Access Compliance Report

Public Rights-of-Way

Intersection ID: 48454	Main Street: RED_RUST_LN	Cross Street: GOLF_LINKS_DR	Location: NE
ADA ID: 445CC89E9B69	Ramp Type: Perp	Initial Pass/Fail: Fail	Overall Compliance: No Severity Score: 13.75

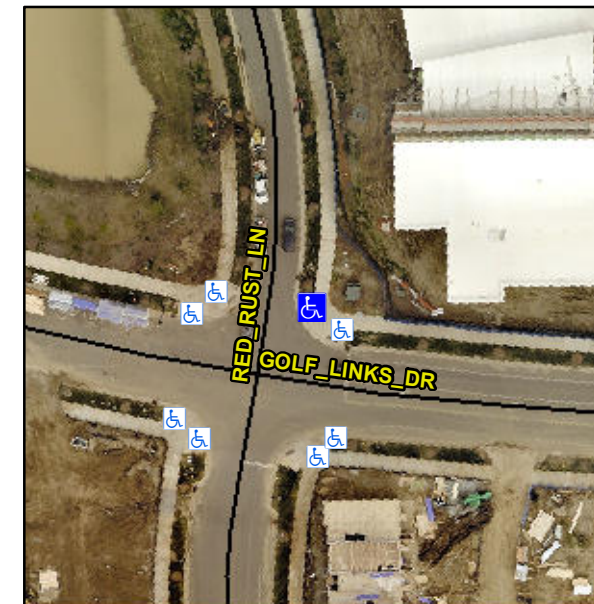
R304.2.2, R304.5.3

Compliance	Description	Data	Compliance	Description	Data
N/A	Ramp Length (in)	94.0	No	Ramp Slope (%)	9.1
Yes	Ramp Width (in)	61.0	No	Ramp XSlope (%)	5.0
N/A	Flare Type LT	N/A	N/A	Flare Type RT	N/A
N/A	Flare Slope LT (%)	N/A	N/A	Flare Slope RT (%)	N/A
N/A	Flare Traversable LT?	N/A	N/A	Flare Traversable RT?	N/A
N/A	Landing Length (in)	N/A	N/A	DWS Provided?	N/A
N/A	Landing Width (in)	N/A	N/A	DWS Contrast?	N/A
N/A	Landing Slope (%)	N/A	N/A	DWS Length (in)	N/A
N/A	Landing X Slope (%)	N/A	N/A	DWS Full Width?	N/A
N/A	Landing Curb? (Y/N)	N/A	N/A	DWS Offset (in)	N/A
N/A	Shared Landing?	N/A			
N/A	Gutter Ponding?	N/A	N/A	Gutter Slope (%)	N/A
N/A	Gutter Lip Ht (in)	N/A	N/A	Gutter X Slope (%)	N/A
N/A	Painted X Walk1?	No	N/A	Painted X Walk2?	N/A
	X Walk 1 Direction	To W		X Walk 2 Direction	N/A
N/A	X Walk 1 Width (in)	N/A	N/A	X Walk 2 Width (in)	N/A
	X Walk 1 Slope (%)	2.4		X Walk 2 Slope (%)	N/A
	X Walk 1 X Slope (%)	4.9		X Walk 2 X Slope (%)	N/A

Remove & Replace Entire Ramp.
